PLAN COMMISSION MEETING AGENDA

MONDAY, JULY 08, 2024 AT 4:30 PM

TO: Plan Commission
DATE: July 8th, 2024
SUBJECT: 211 Hiawatha St. - Conditional Use Permit (CUP) & Site Plan Review

A request by MSI General, agent for Go Riteway, for a Conditional Use Permit (CUP) for Outdoor Storage or Wholesaling and approval of a Site Plan for redevelopment of an existing school bus storage yard. Parcel PIN: 291-0915-3234-002.

Sheet Title:
SITE PLAN

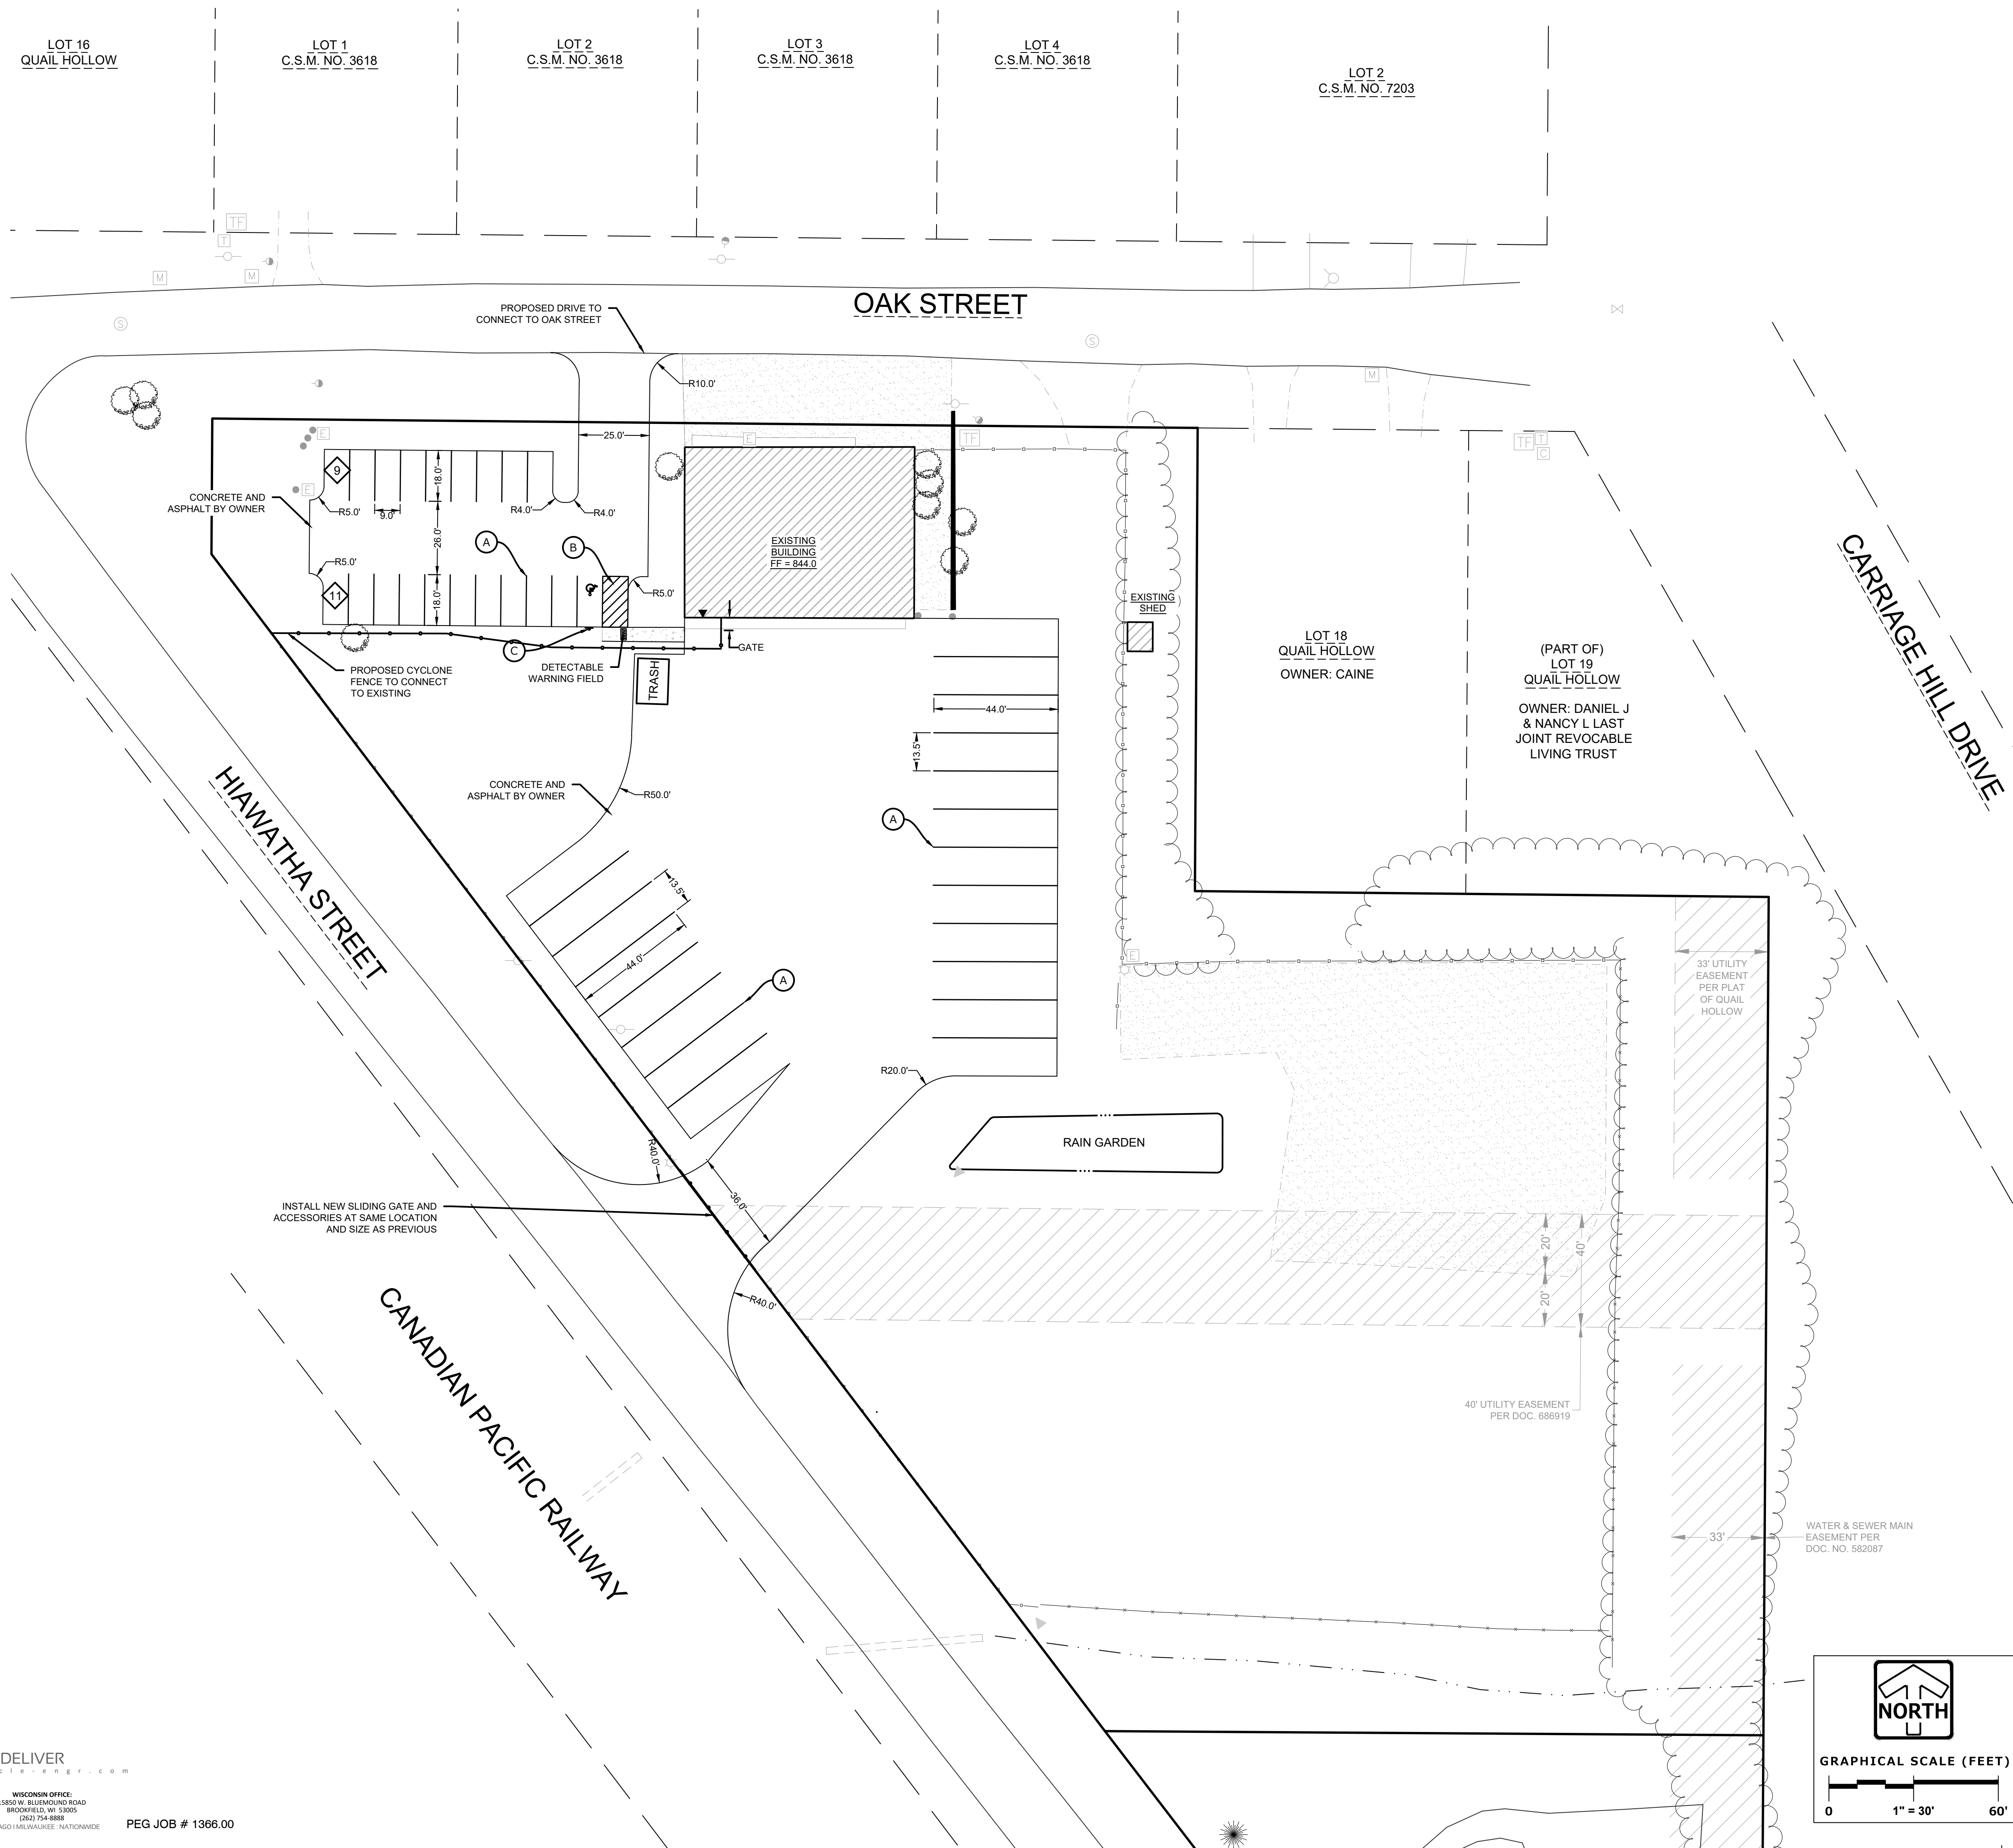
The proposed site plan meets all requirements for vehicle access and traffic circulation with the exception of parking stall depth. Parking stalls are required to be 18.5 feet in depth. [per § 550-107]

Landscape point calculations have not been provided by the applicant in the site plan. The LSR (Landscape Surface Ratio) for General Industrial (GI) Zoning is a minimum of 15%.

1. Deny the Conditional Use Permit and Site Plan.
2. Approve the Conditional Use Permit and Site Plan without conditions.
3. Approve the Conditional Use Permit and Site Plan with conditions as identified by the Plan Commission:
 - a) Applicant shall provide a landscaping plan that meets the requirements of Article X – Landscaping and Bufferyard Regulations (§550-93 thru §550-103 and Appendix F).
 - b) Applicant shall adjust parking stall depth to the required 18.5 ft in employee/customer parking lot and maintain a minimum pavement setback of 10 feet from ROW line.
 - c) Applicant shall obtain an Erosion Control & Storm Water Runoff Permit.
 - d) Applicant shall obtain sign permits for any proposed on-building or on-site signage.
